Access Compliance Report

Public Rights-of-Way

Intersection ID: 9687	Main Street: N_PINE_ST	Cross Street: W_28TH_ST	Location: NW
ADA ID: 4BED734F90B0	Ramp Type: Perp	Initial Pass/Fail: Fail	Overall Compliance: No
		Severity Score: 25

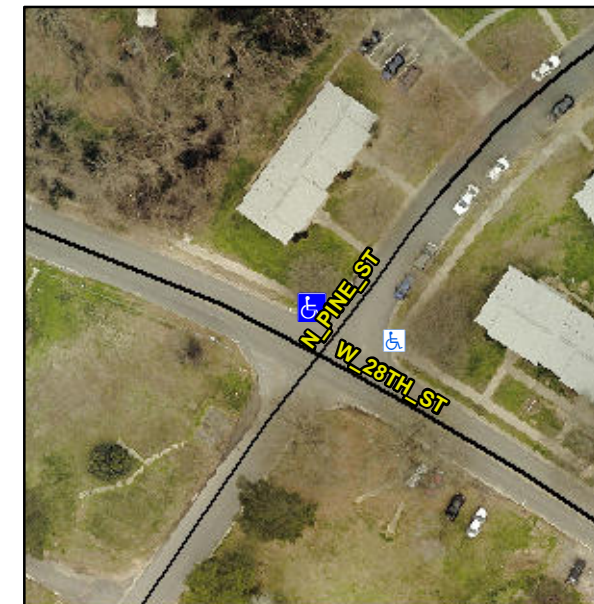
Not Found, R304.2.2

Compliance	Description	Data	Compliance	Description	Data
N/A	Ramp Length (in)	53.0	No	Ramp Slope (%)	13.8
Yes	Ramp Width (in)	49.0	Yes	Ramp XSlope (%)	1.7
N/A	Flare Type LT	N/A	N/A	Flare Type RT	N/A
N/A	Flare Slope LT (%)	N/A	N/A	Flare Slope RT (%)	N/A
N/A	Flare Traversable LT?	N/A	N/A	Flare Traversable RT?	N/A
N/A	Landing Length (in)	N/A	N/A	DWS Provided?	N/A
N/A	Landing Width (in)	N/A	N/A	DWS Contrast?	N/A
N/A	Landing Slope (%)	N/A	N/A	DWS Length (in)	N/A
N/A	Landing X Slope (%)	N/A	N/A	DWS Full Width?	N/A
N/A	Landing Curb? (Y/N)	N/A	N/A	DWS Offset (in)	N/A
N/A	Shared Landing?	N/A			
N/A	Gutter Ponding?	Yes	N/A	Gutter Slope (%)	N/A
N/A	Gutter Lip Ht (in)	0.5	N/A	Gutter X Slope (%)	N/A
N/A	Painted X Walk1?	No	N/A	Painted X Walk2?	N/A
	X Walk 1 Direction	To SE		X Walk 2 Direction	N/A
N/A	X Walk 1 Width (in)	N/A	N/A	X Walk 2 Width (in)	N/A
	X Walk 1 Slope (%)	0.8		X Walk 2 Slope (%)	N/A
	X Walk 1 X Slope (%)	0.1		X Walk 2 X Slope (%)	N/A

Remove & Replace Entire Ramp.
